## SERVICE INFORMATION NO. SI D4-107

GARMIN – Service Bulletin No. 0823  
ATA-Code: 34-00

**NO.: 0823**

**SUBJECT:** GDU 104X CRS/BARO Knob Interference

**Figure 1**

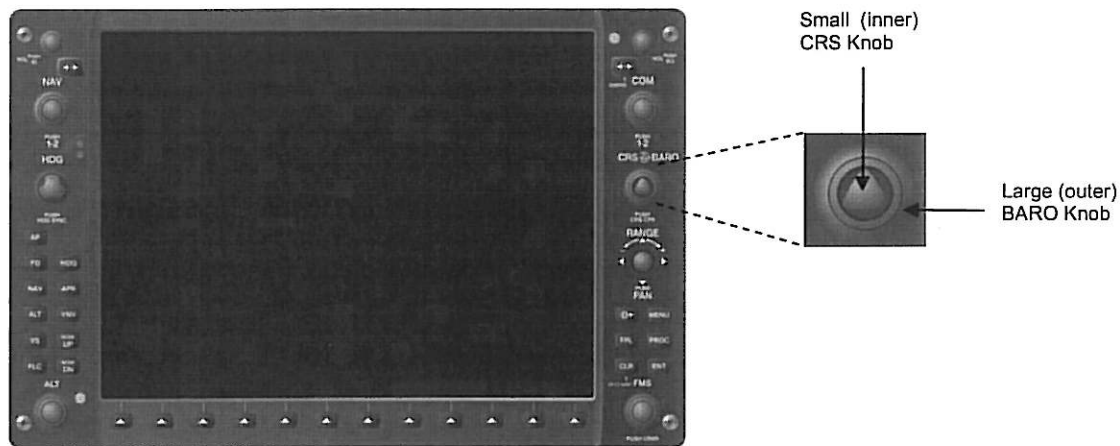
Garmin has identified an issue, whereby the large (outer) BARO knob and the small (inner) CRS knob may interfere with each other.

1. Apply power to the G1000/G900X/G950.
2. Press the CDI softkey on the Primary Flight Display(s) (PFD) to enter VOR mode on the HSI.
3. Rotate the large (outer) BARO knob (refer to Figure 1) a minimum of three complete revolutions in each direction while monitoring the Horizontal Situation Indicator/Digital Course Indicator (refer to Figure 2) on the PFD. If a change in the Horizontal Situation Indicator/Digital Course Indicator is produced while turning the BARO knob proceed to the Modification Instructions.

4. Rotate the small (inner) CRS knob (refer to Figure 1) a minimum of three complete revolutions in each direction while monitoring the Barometric Altimeter Setting (refer to Figure 2) on the PFD. If a change in the Barometric Altimeter Setting is produced while turning the CRS knob proceed to the Modification Instructions.
5. Repeat Steps 3 and 4 for each affected GDU.

If CRS/BARO Knob interference is confirmed, perform the steps below to replace the CRS/BARO Knob. New knobs can be obtained through a Garmin Service Center or Aircraft OEM under Garmin part number K00-00446-00.

1. Grasp the small (inner) CRS knob and firmly pull the knob off the shaft.
2. Discard knob.
3. Grasp the large (outer) BARO knob and firmly pull the knob off the shaft.
4. Discard knob.

**Figure 3**

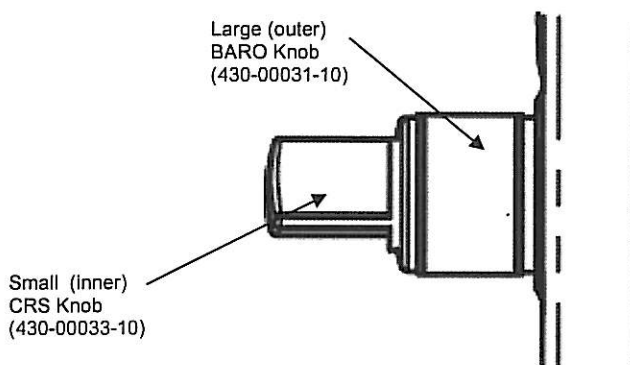
5. Grasp the large (outer) BARO knob (insuring proper orientation) and place it over the shaft.
6. Align the flat side of the knob insert with the flat side of the shaft.
7. Press down firmly to ensure knob is completely seated, refer to Figure 3.
8. Grasp the small (inner) CRS knob (insuring proper orientation) and place it over the shaft.
9. Align the flat side of the knob insert with the flat side of the shaft.
10. Press down firmly to ensure knob is completely seated, refer to Figure 3.
11. Perform the CRS/BARO Knob Interference Test (contained in the TESTING PROCEDURE section) again to confirm there is no interference.
12. Accomplish aircraft logbook entry to return aircraft to service in compliance with this service bulletin.
